UNITED STATES
NUCLEAR REGULATORY COMMISSION
WASHINGTON, D.C. 20555-0001

May 10, 2017

SUBJECT: BRAIDWOOD STATION, UNITS 1 AND 2 - SAFETY EVALUATION
REGARDING IMPLEMENTATION OF MITIGATING STRATEGIES AND
RELIABLE SPENT FUEL POOL INSTRUMENTATION RELATED TO ORDERS
EA-12-049 AND EA-12-051 (CAC NOS. MF0895 AND MF0896)

Figure 1 – Braidwood SFP Levels of Monitoring

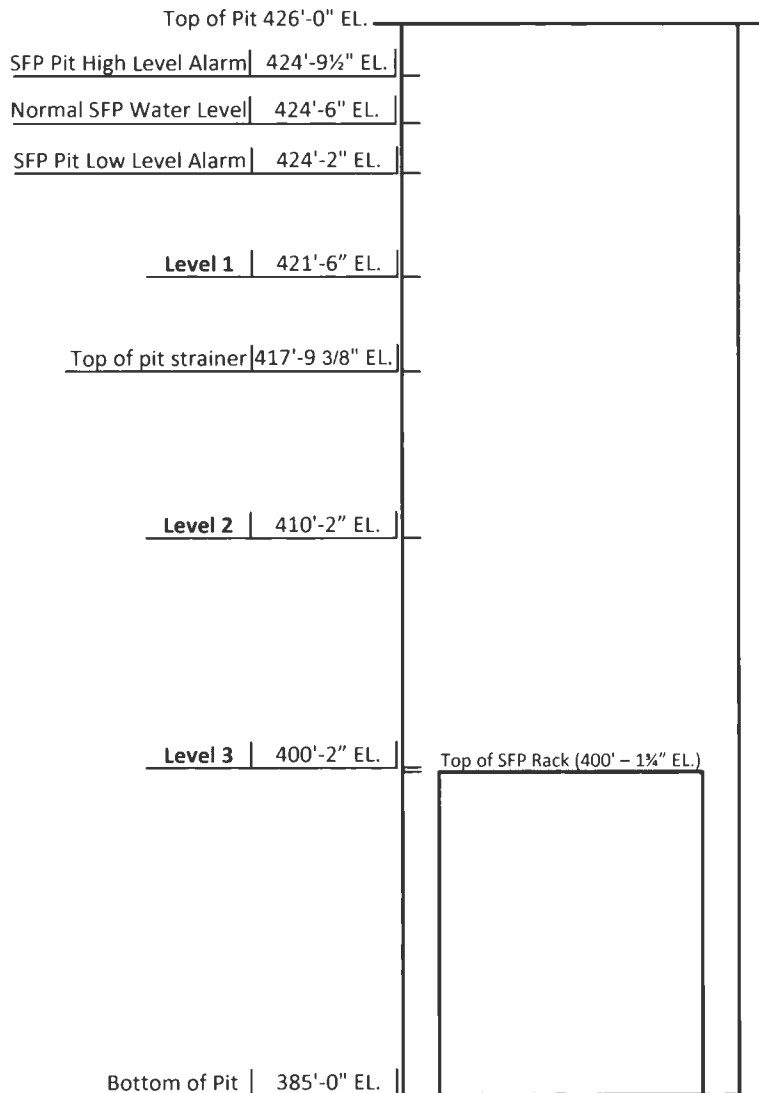
In its email dated February 15, 2017 [Reference 35], the licensee also provided a sketch depicting the revised SFP levels of monitoring as illustrated below in Figure 1, "Braidwood SFP Levels of Monitoring."
